service bulletin

No. 92-13

Gearcase Oil Slinger Eliminated - 1992 135 thru 200

Mariner and Mercury

Figure 1. Oil Slinger Location

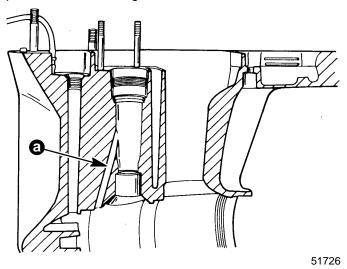
The gearcase oil slinger p/n 23–43998 is not installed in the gearcase on the models listed. This change was made in conjunction with enlargement of the oil circulation hole from 1/4 inch (6.3 mm) diameter to 3/8 inch (9.5 mm) diameter. The enlargement of the oil circulation hole was made prior to removing the oil slinger to eliminate any assembly error.

Gearcases with a 1/4 inch (6.3 mm) oil circulation hole must continue to have the oil slinger installed.

IMPORTANT: Gearcases with the 1/4 inch (6.3 mm) diameter oil circulation hole REQUIRE the oil slinger p/n 23–43998 to provide lubrication to the upper bearing.

Figure 2. 135 thru 200 Gearcase

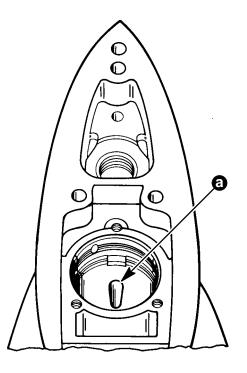
The oil circulation hole connects the torpedo area to the upper drive shaft bearing area.

Gearcases with a 3/8 inch (9.5 mm) oil circulation hole may or may not have the oil slinger installed without any adverse affect.
